**IN REPLY REFER TO:  
L-175-02-202**

**RE: 1964, S/N: 310I0145  
310I; N8145M  
DA: 07/04/02  
San Dimas, CA  
NTSB Report #: LAX02FA214**

MEB88-3

AUXILIARY FUEL PUMP WIRING MODIFICATION

Figure 3. Wiring Diagram - Sheet 3

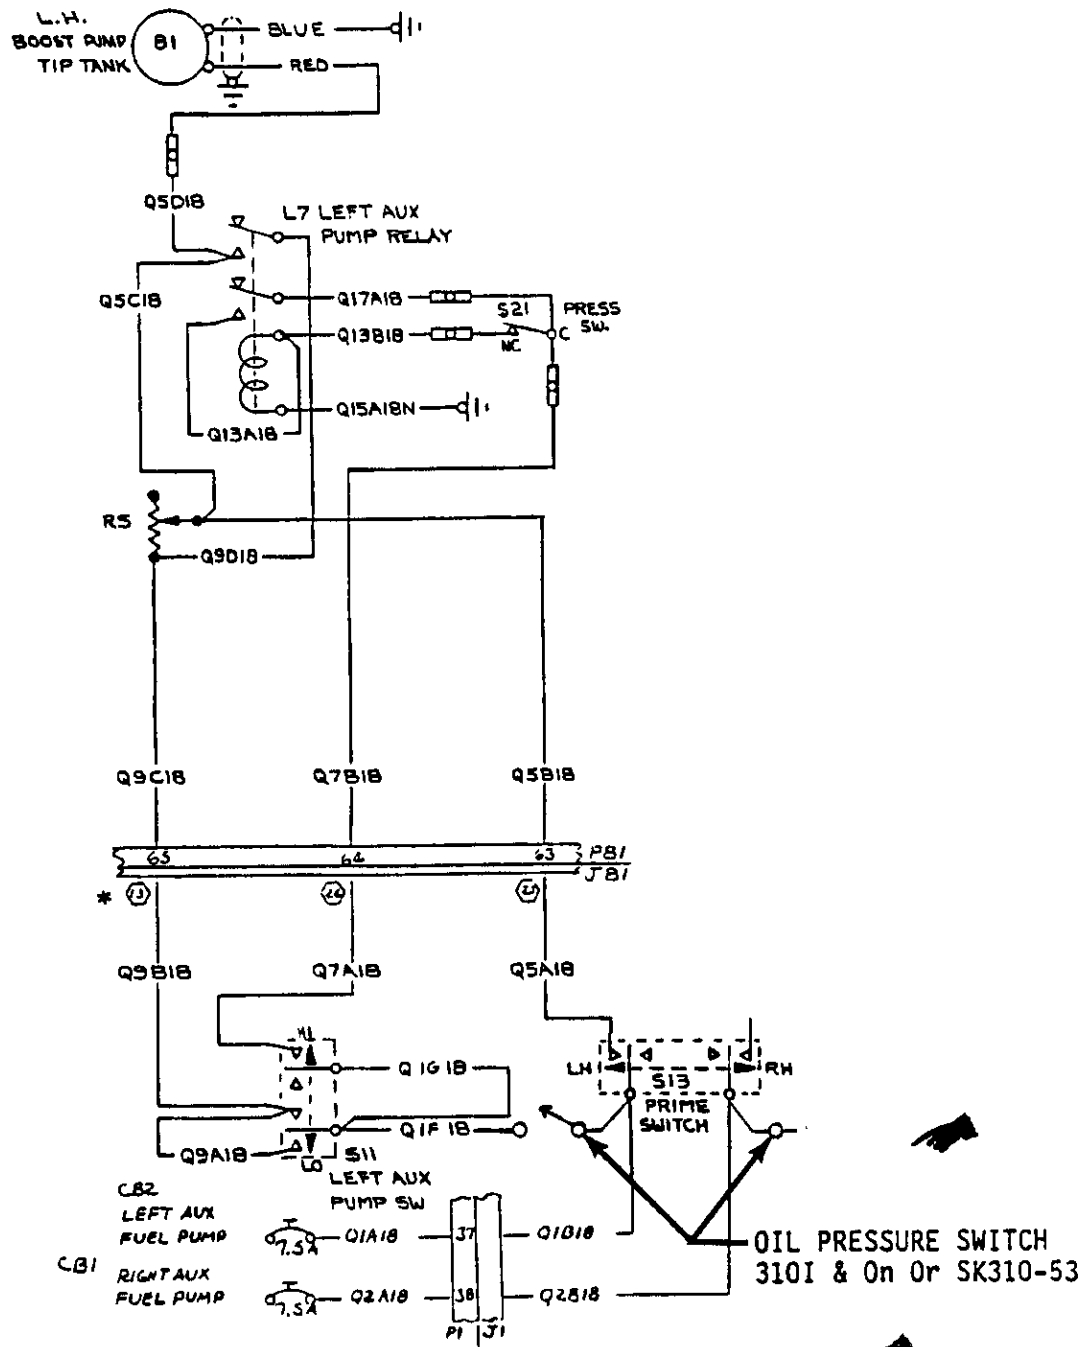
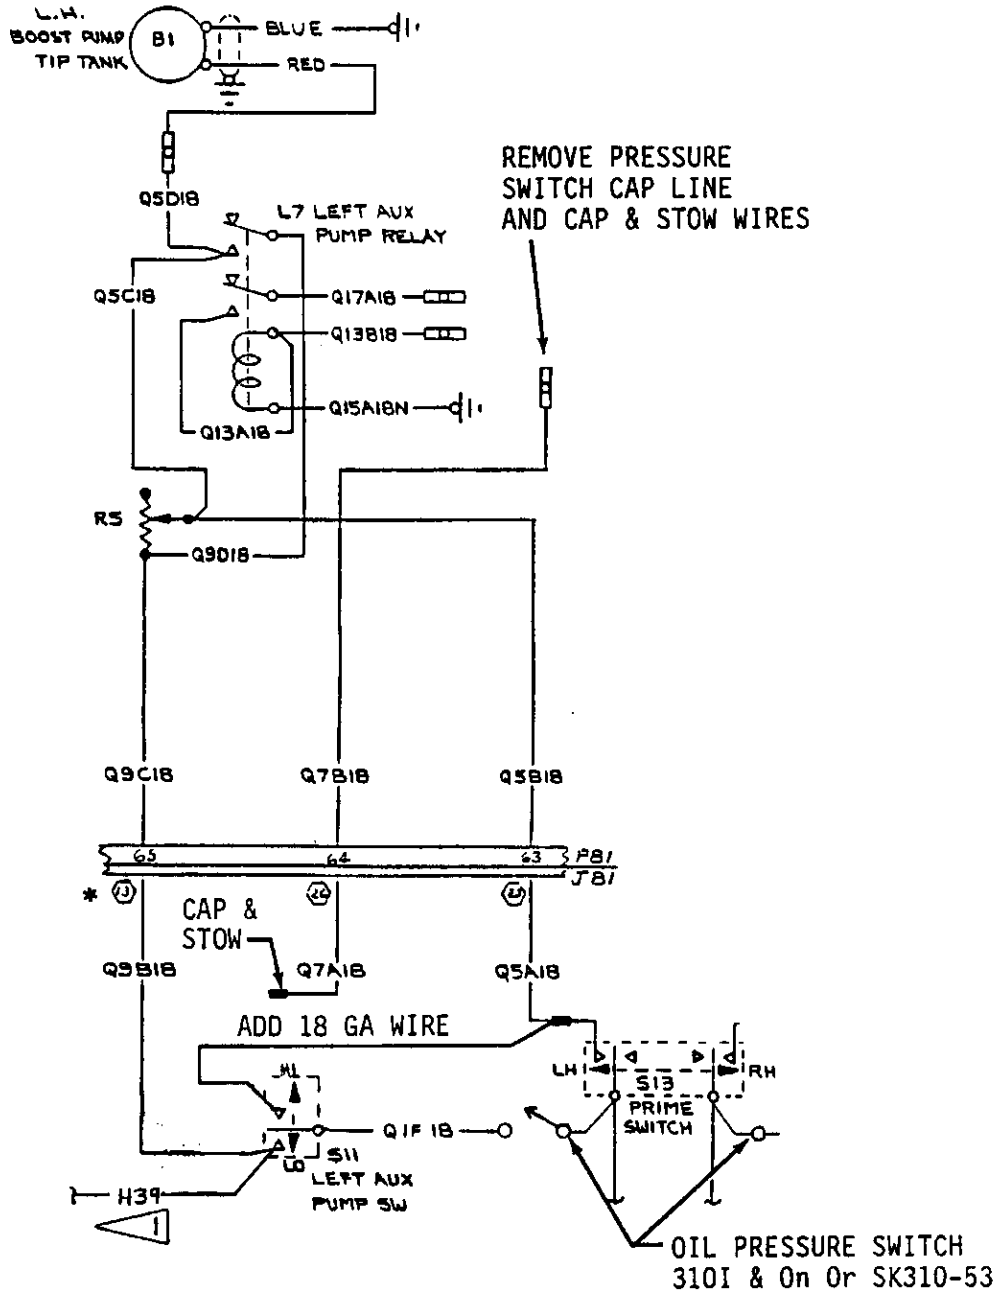
- F. Modify existing wiring per appropriate wiring diagrams (refer to Figure 3 - Sheets 1 thru 8).
1. This modification bypasses boost relay.
  2. Low boost circuit is unchanged.

Figure 3. Wiring Diagram - Sheet 7

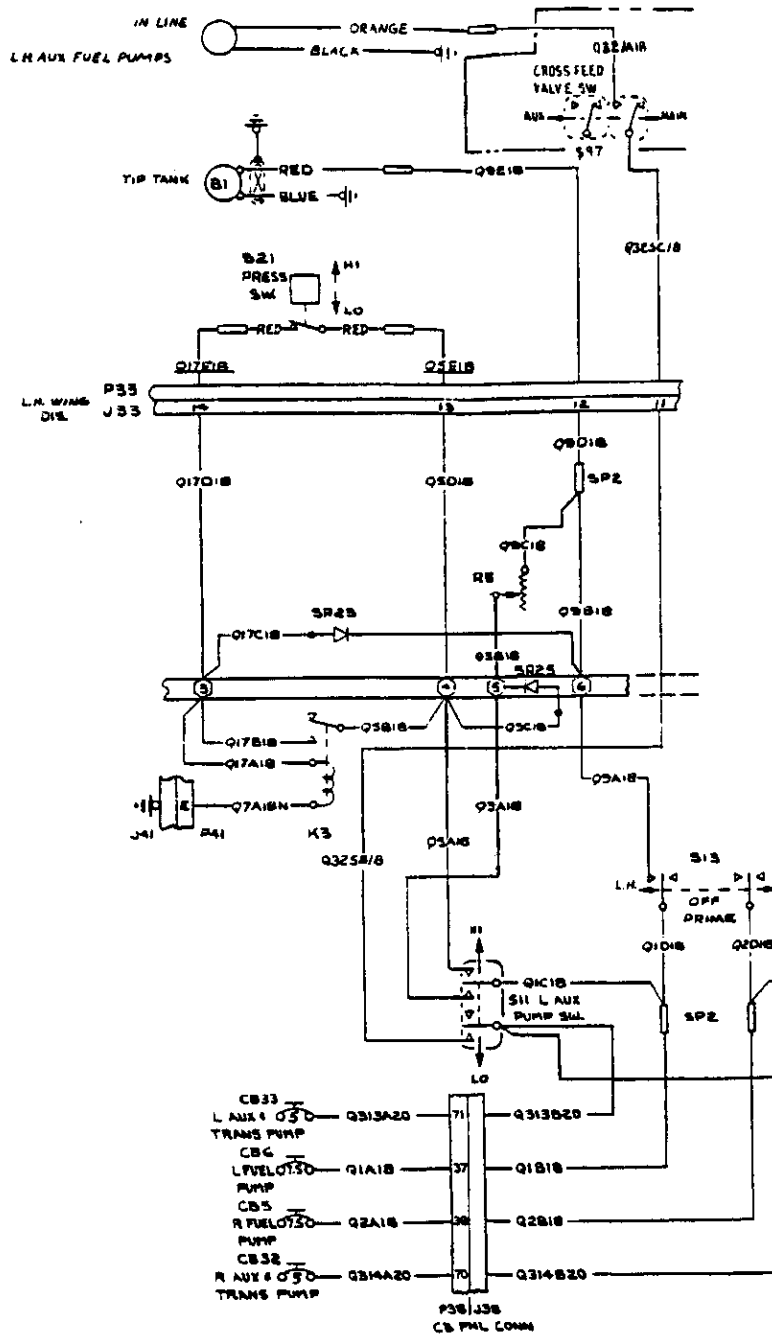
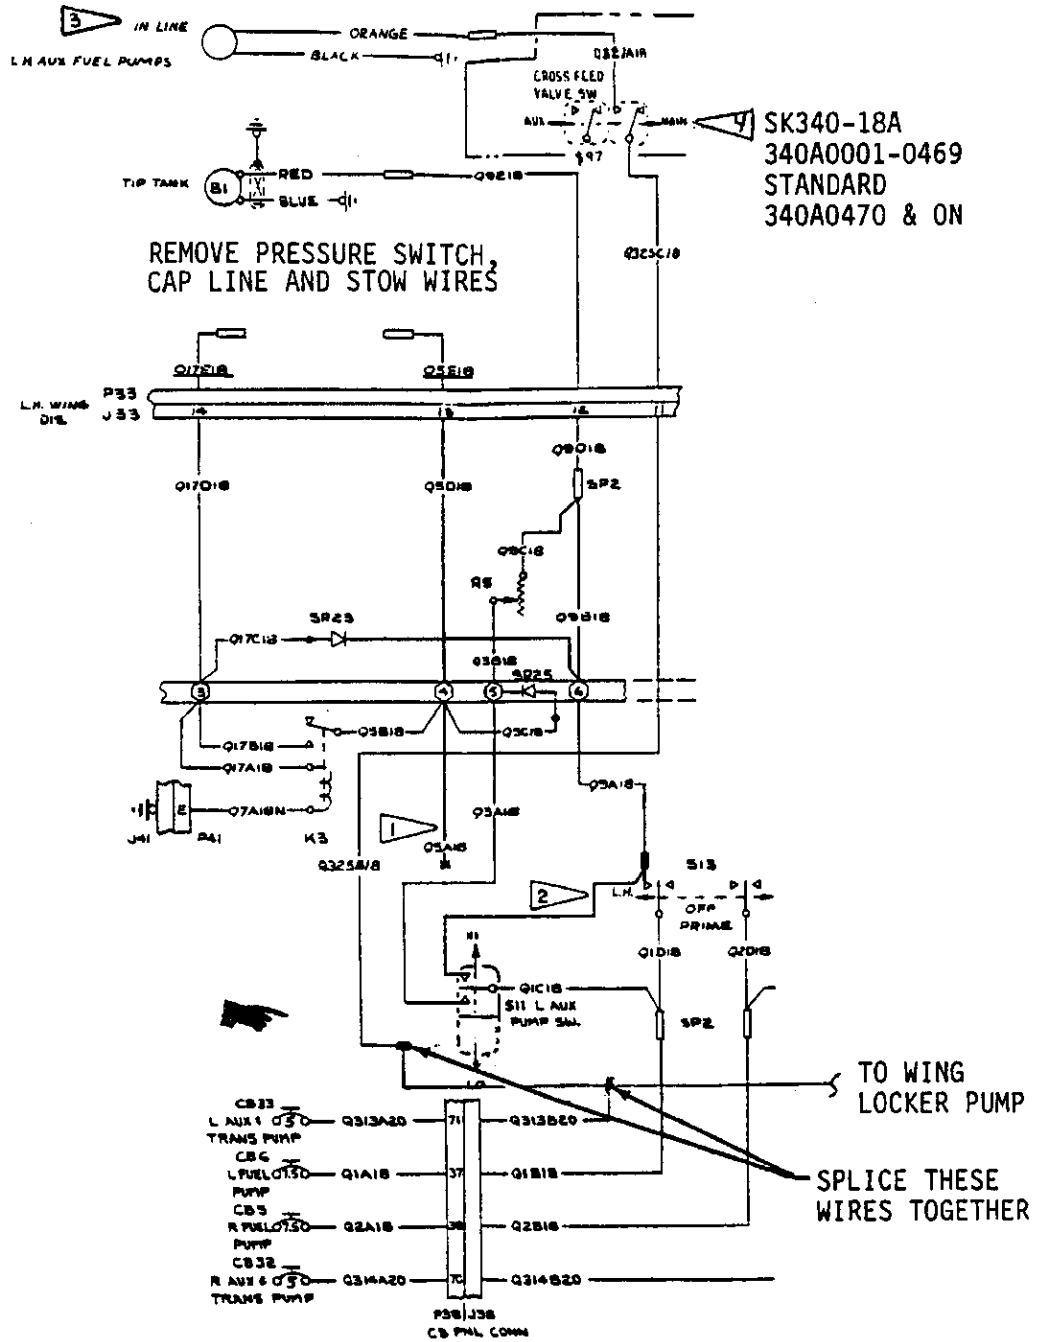
3 AUX FUEL PUMPS - IN LINE  
EFFECTIVE ON 340A0001 & ON  
LH SHOWN, RH OPPOSITE

1 CAP & STOW WIRE  
2 ADD 18 GA WIRE
